**From:** Priscilla Burton  
**To:** Kent Fawcett; OGMCOAL  
**CC:** Campbell, Ingrid; John Lee  
**Date:** 11/9/2010 5:32 PM  
**Subject:** 007001 White Oak, Outgoing, White Oak Seeding  
**Attachments:** site overview DSCN2826.JPG; roads and terraces\_20101109173536.pdf

**WO-8**      **Terraces & Access Roads**

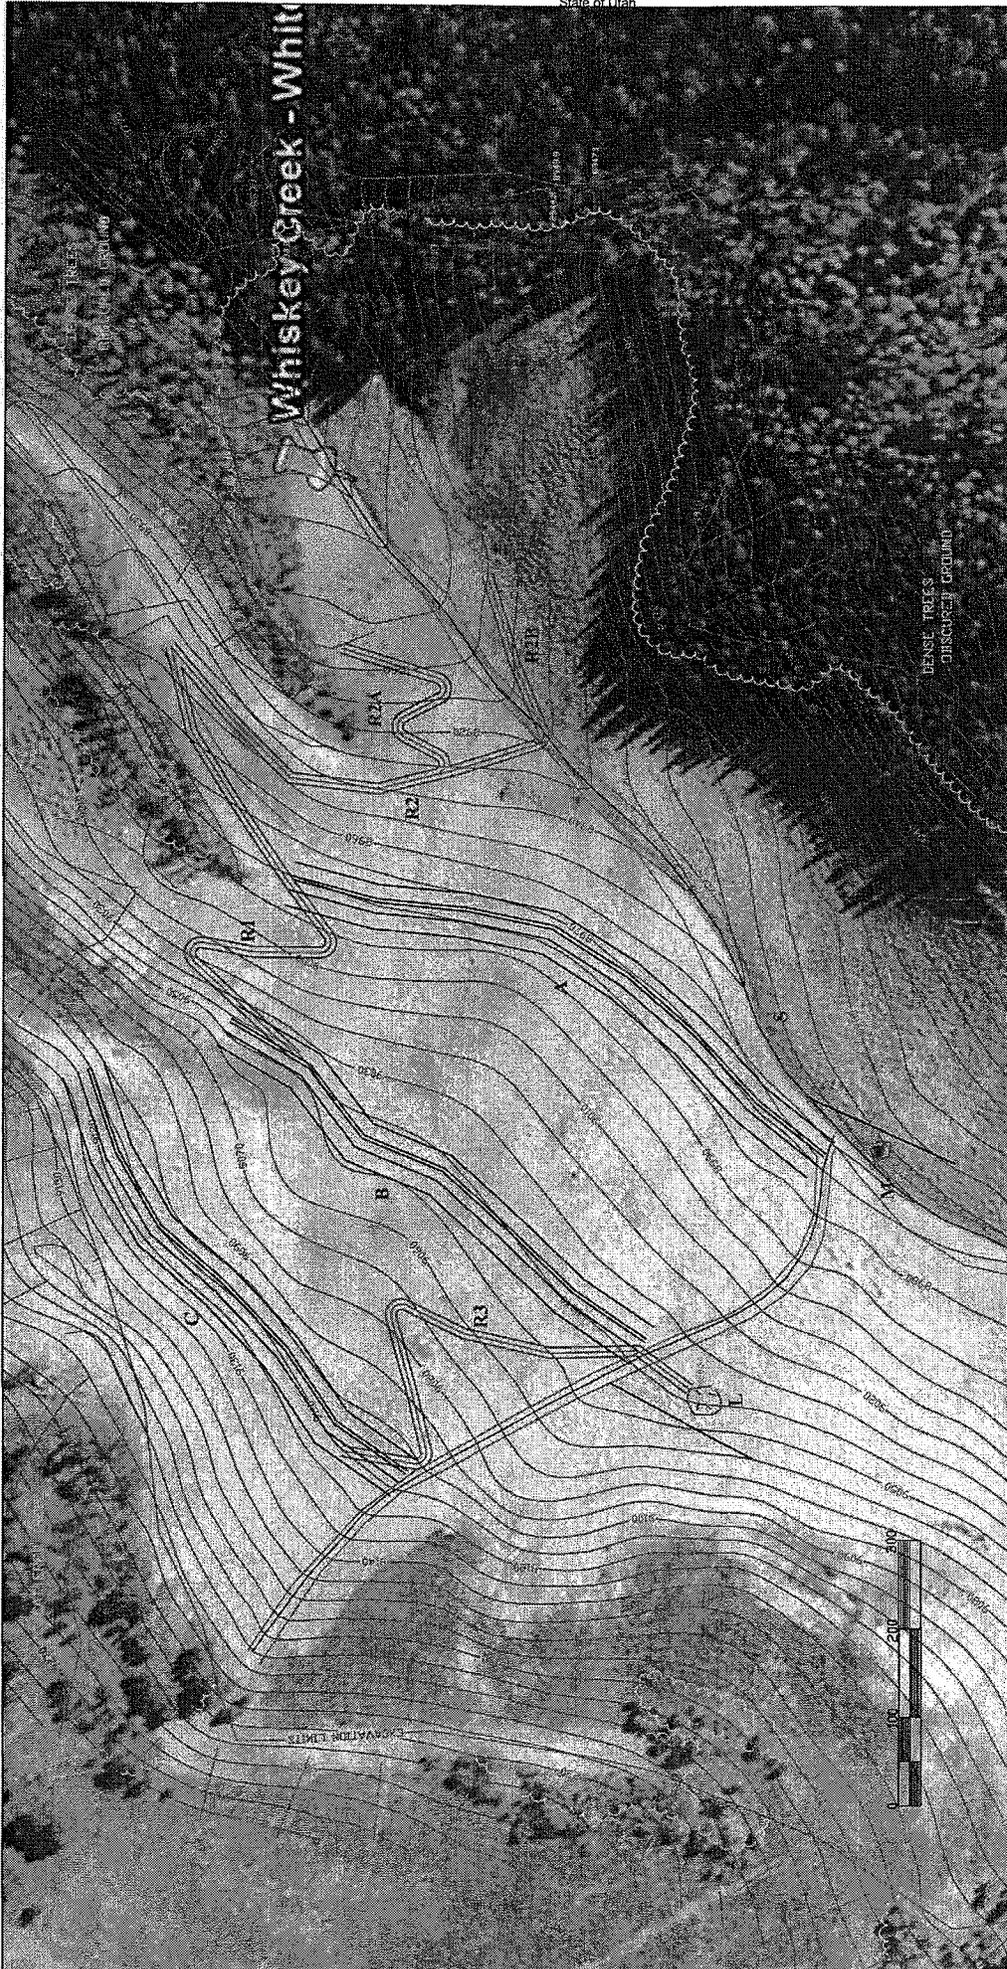
John and I discussed hand seeding the seed mix on the following areas that have had biosolids and straw incorporated (see Dwg WO-8 attached):

Terrace C surface and inslope of berm and cut ( 0.3 acre).

The remaining slope above Terrace B (2 acres).

The slope between Terrace B and A (6 acres).

The following areas did not receive straw, but were left rough and are far enough along that they should be seeded with the final mix and covered with straw:

The reclaimed access road R3 and disturbed area across the side channel from Terrace C (1 acre).

The "eyebrow" ( 0.01 acre).

**Stream channel area (including excess spoil pile) in the vicinity of R2A and stream reach 3 & 4 ( approx. 2 acres) will be redisturbed next season and should have Triticale seed applied ASAP. If possible, also scatter straw over the area.**

There is an area below terrace A that was heavily traveled by the excavator which should also receive Triticale. It can be seen on the attached overview image. If you can tell its location beneath the snow..seed it too, please. I estimate approximately 0.3 acres

John is having a couple loads of wood straw delivered. Woodstraw should only be applied to areas where the biosolids and straw have been incorporated and the ground is seeded with the final mix (about 9 acres upslope from Terrace A). If that gets scattered, I'd be delighted.
